APPLICATION NO.	FILING DATE	FIRST NAMED INVENTOR	ATTORNEY DOCKET NO.	CONFIRMATION NO.
10/823,780	04/14/2004	Yasuyuki Kojima	101077.53988US	4691

KOCA, HUSEYIN

Office Action Summary

Fig. 1 – Drawing 1 from Bunkou et al. (JP-A-2002-243248).

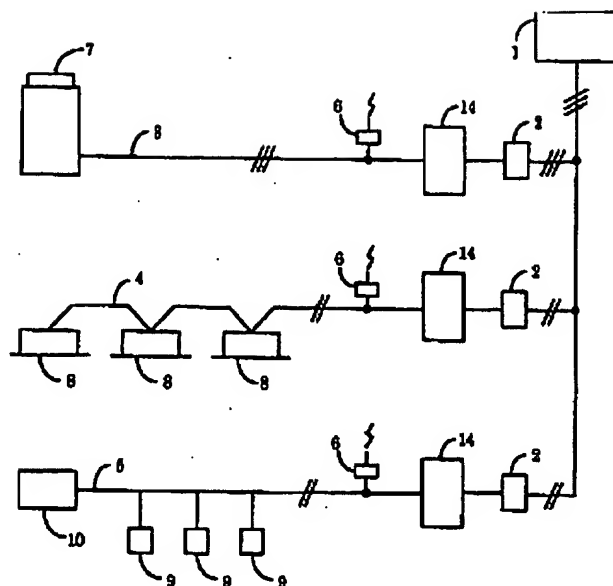
In regard to claim 1, referring to Fig. 1, Bunkou et al. teach an air conditioning system having indoor units (8), an outdoor unit (7), and a system controller (10) for controlling the indoor or the outdoor unit by executing communications as transmitting a signal via power line supplying electric power (0018, line 1; 0024, line 2-8). Bunkou et al. teach a line that is used for connecting the outdoor unit with the system controller. This line corresponds to the claimed leased communication line and is taught in "Detail Description of the Invention" (0015, line 12; 0025, lines 1-2). Power line communication is provided from the indoor unit via power line (0019, line 5-8). A bridge (6) is used for connecting the communication lines (0020, line 3-8). The control information is exchanged mutually between the indoor unit, outdoor unit, and the system controller (0024, line 2-9).

In regard to claim 2, Bonkou et al. supply electric power to the indoor unit through a single-phase power line and to the outdoor unit through three-phase power line. See Fig. 1 above where the single-phase power line is marked as (//) and the three-phase power line is marked as (///). The single-phase power line is connected with three-phase power line through leased communication path (0015, line 12-15).

In regard to claim 1, referring to Fig. 1, Bunkou et al. teach an air conditioning system having indoor units (8), an outdoor unit (7), and a system controller (10) for controlling the indoor or the outdoor unit by executing communications as transmitting a signal via power line supplying electric power (0018, line 1; 0024, line 2-8). Power line communication is provided from the indoor unit via power line (0019, line 5-8). A bridge (6) is used for connecting the communication lines (0020, line 3-8). The control information is exchanged mutually between the indoor unit, outdoor unit, and the system controller (0024, line 2-9). Bunkou et al. do not explicitly teach using a leased communication line. Roh teaches using leased communication line (50) for connecting outdoor unit with the system controller (C-3; L-7-10). It would have been obvious to one having ordinary skill in the art at the time the invention was made to use leased communication line as taught by Roh, in Bunkou et al. system, in order to have faster data transfer rates.

In regard to claim 2, Bonkou et al. supply electric power to the indoor unit through a single-phase power line and to the outdoor unit through three-phase power line. See Fig. 1 above where the single-phase power line is marked as (//) and the three-phase power line is marked as (///). The single-phase power line is connected with three-phase power line through leased communication path (0015, line 12-15).

Fig. 2 – Figure 57 from Masui et al. (US 2003/0140637 A1)

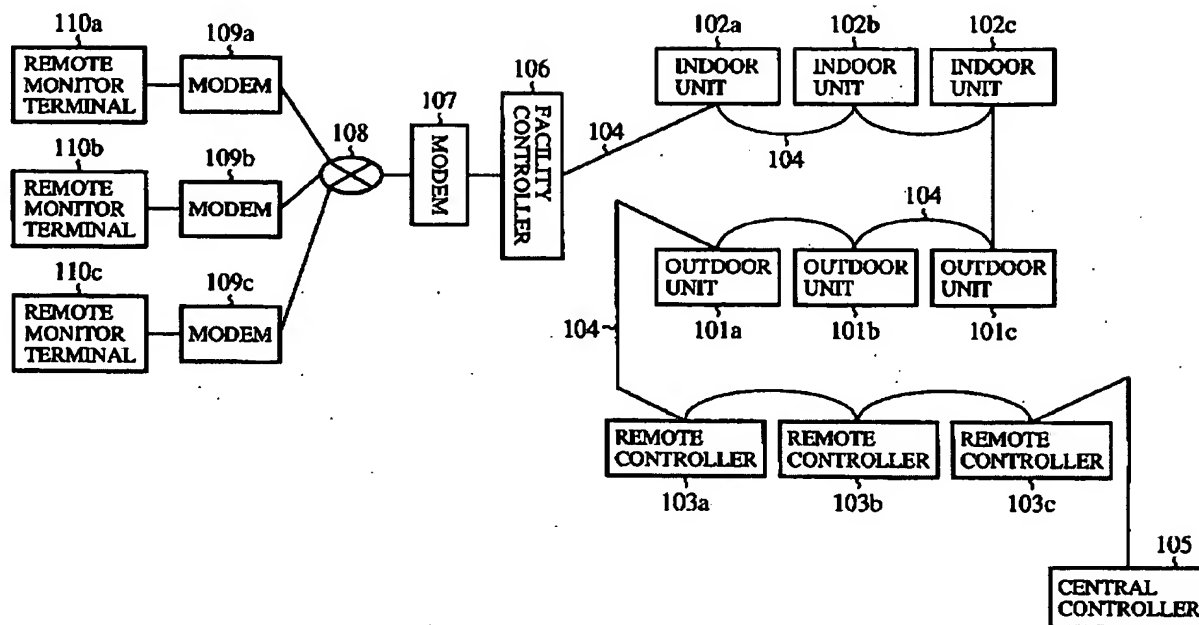
In regard to claim 11, referring to Fig. 1, Bunkou et al. teach an air conditioning system having indoor units (8), an outdoor unit (7), and a system controller (10) for controlling the indoor or the outdoor unit by executing communications as transmitting a signal via power line supplying electric power. Power line communication is provided from the indoor unit via power line (0019, line 5-8). A bridge (6) is used for connecting the communication lines (0020, line 3-8). The control information is exchanged mutually between the indoor unit, outdoor unit, and the system controller (0024, line 2-9). Bunkou et al. do not explicitly teach using leased communication line or high-speed communication device. Roh teaches using leased communication line (50) for connecting outdoor unit with the system controller (C-3; L-7-10) and provides high-speed communication (40) via a server (C-3; L-2-6). Roh does not explicitly teach using a modem for high-speed communication means. Masui et al. teach using modem (107) for high-speed communication and provide an adapter which connects to high speed communication line and the power line (0004, 0005). It would have been obvious to one having ordinary skill in the art at the time the invention was made to use a high speed

communication as taught by Masui et al. and Roh, in Bunkout et al. system to transfer data faster.
